TO: Mercedes-Benz Dealer Principals, General Managers, Sales Managers, Service Managers, Parts Managers	FROM: Thomas Brunner, Department Manager, Vehicle Compliance and Analysis, Engineering Services
RE: Service Campaign 2016070002 Models 166, 205; Model Years 2016 Replace Collision Prevention Assist (CPA) Sensor	DATE: July 29, 2016

Campaign No. 2016070002, July 2016

SUBJECT: **Models 166, 205; Model Years 2016**
Replace Collision Prevention Assist (CPA) Sensor

AR30.30-P-1210LW	Remove/install radar sensor	1.9.15
------------------	-----------------------------	--------

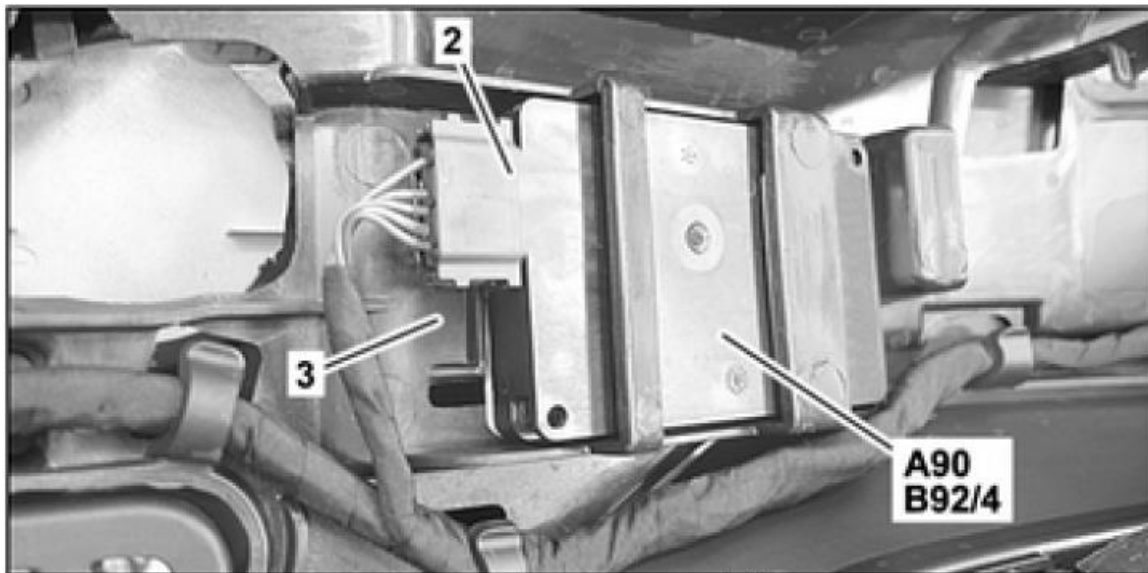
- Correction to step 4 (this will be corrected in a future WIS release):

“4. **Push down on locking tab (3)** and remove front left bumper radar sensor (B92/3) or front right bumper radar sensor (B92/4) or COLLISION PREVENTION ASSIST controller unit (A90)”.

- Supplemental information to step 6:
Perform initialization using SDS after installing new CPA sensor (follow on-screen instructions).
